MODIFICATION RECOMMENDED

N5245AS-01

N5245AS PNA Series Microwave Network Analyzers

July 16, 2012

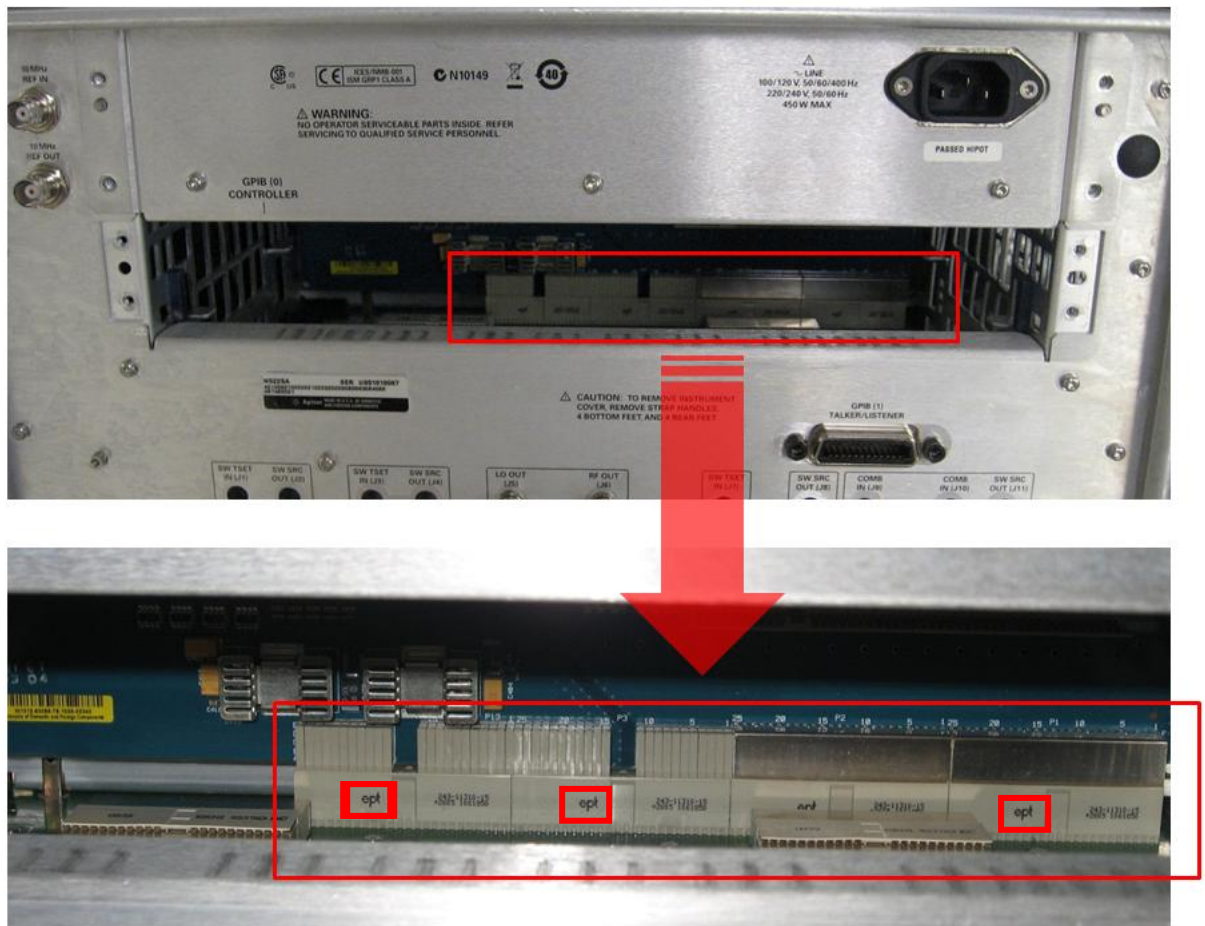
1. Remove the CPU assembly from the analyzer's rear panel. Refer to the PNA Service Guide chapter 7 section titled, "Removing and Replacing the CPU Board Assembly" for removal and reinstallation procedures. To view the online Service Guide, see the numbered list on the next page for instructions.
2. As per the photo below, inspect the system motherboard connector to see if it has one or more "ept" logos.

3. If the connector has one or more “ept” logos, return the analyzer to Agilent for replacement of the system motherboard. If the connector does not have one or more “ept” logos, email support_ctd-soco_support@agilent.com, providing the analyzer model and serial number and details of the malfunction symptoms.

4. *For Agilent Service Technicians only:* Only new boards without “ept” logos should be installed. Before installing the new board, look to see if it has one or more “ept” logos. If so, email support_ctd-soco_support@agilent.com, providing the analyzer model and serial number. Wait for further instructions in an email reply. New boards without “ept” logos can be installed.
For installation instructions, refer to the PNA Service Guide chapter 7 section titled, “Removing and Replacing the System Motherboard.” To view the online Service Guide, see the numbered list on the next page for instructions.
